Bryant Square

Draft Environmental Impact Report

Summary of Comments and Responses

98.635E

Figure 2: Existing Buildings

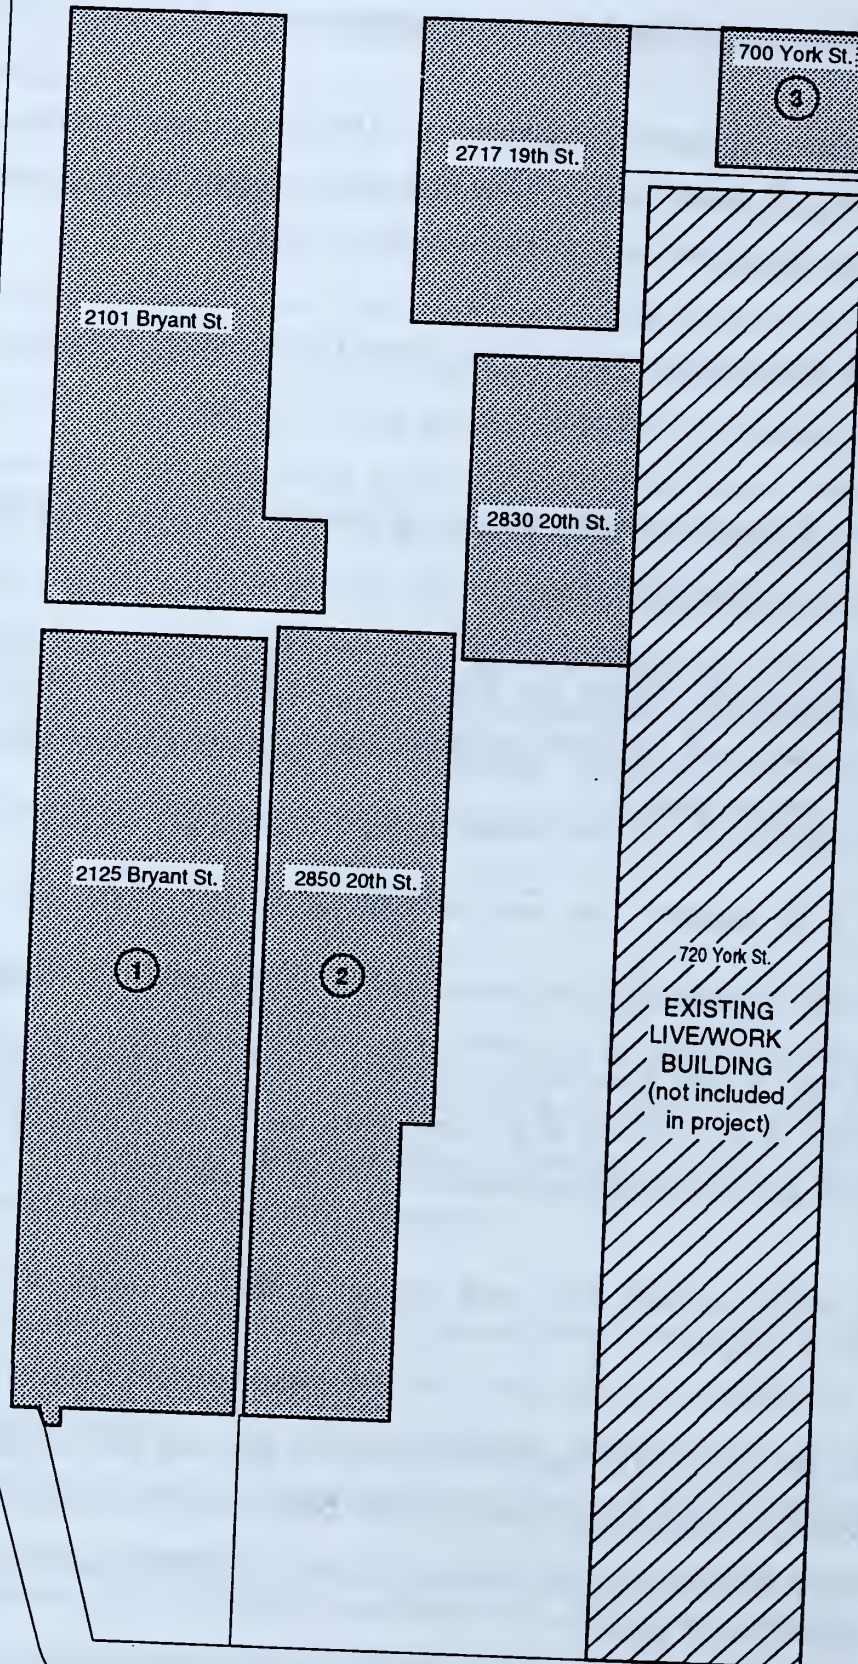
Figures 2: Existing Buildings and 3: Site Plan have been revised to include the building addresses. These can be seen in Section 5.2 Addenda to the Draft EIR of this document as changes to pages 2-5 and 2-6 of the Draft EIR.

Page 2-5: Existing Buildings and Figure 2-6: Site plan have been revised as shown below to include address of the existing and proposed buildings, and to correct the building outline on the site plan (*Response 1b – Project plans*).

Figure 3: Site Plan

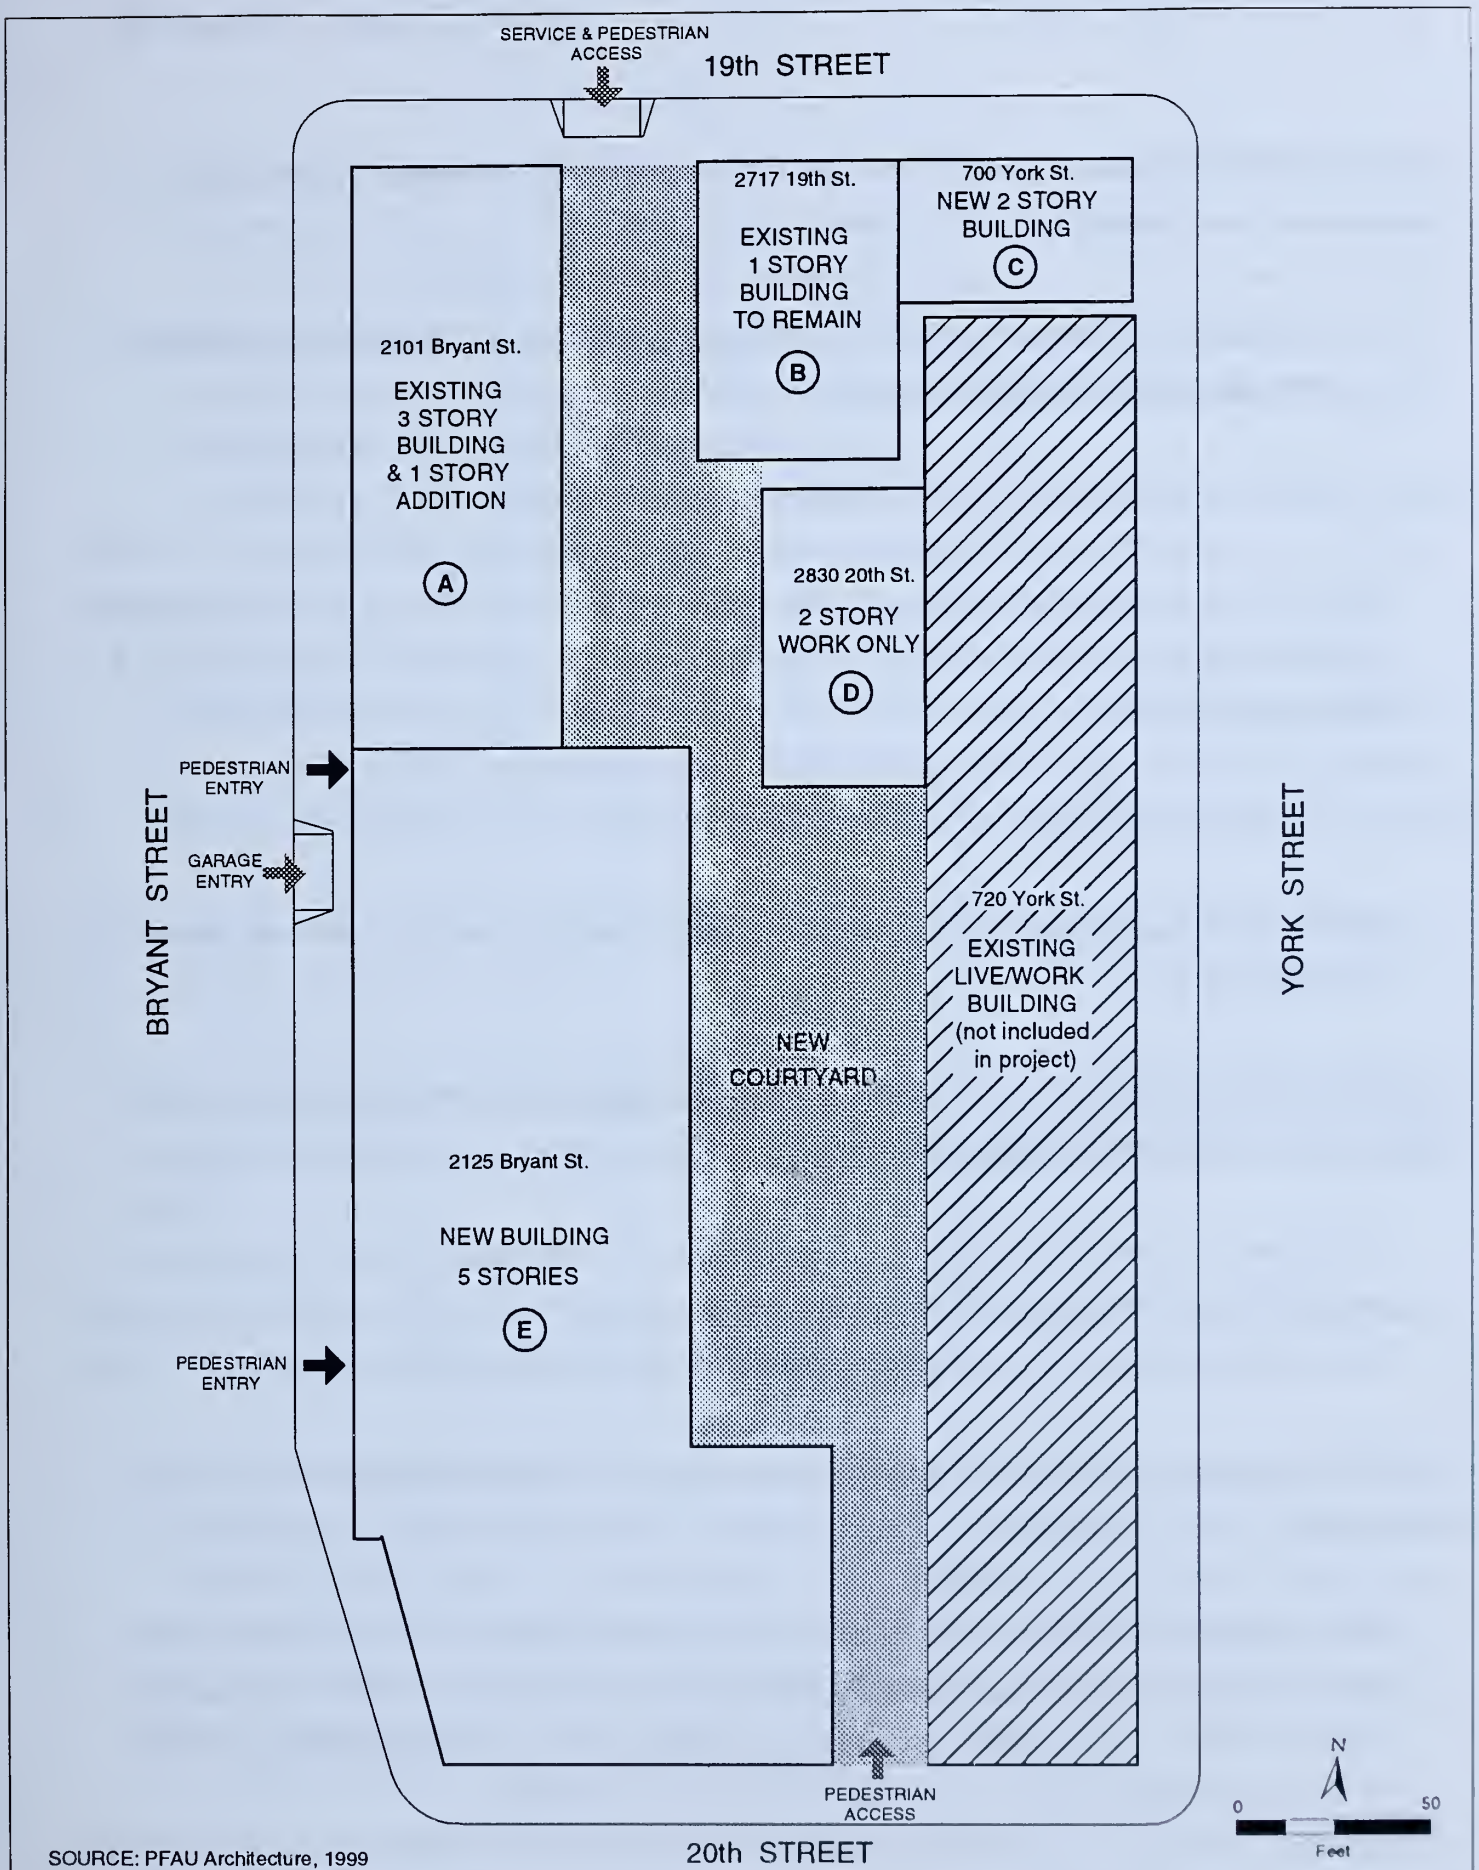
Figure 3: Site Plan shown on page 2-6 of the Draft EIR was from an older design and does not reflect design changes shown in Figure 5: Ground floor plan or in Figure 6: Fourth floor plan, pages 2-9 to 2-10, respectively, of the Draft EIR. In response, the site plan has been revised as shown in Section 5.2 Addenda to the Draft EIR of this document as a change to page 2-6 of the Draft EIR.
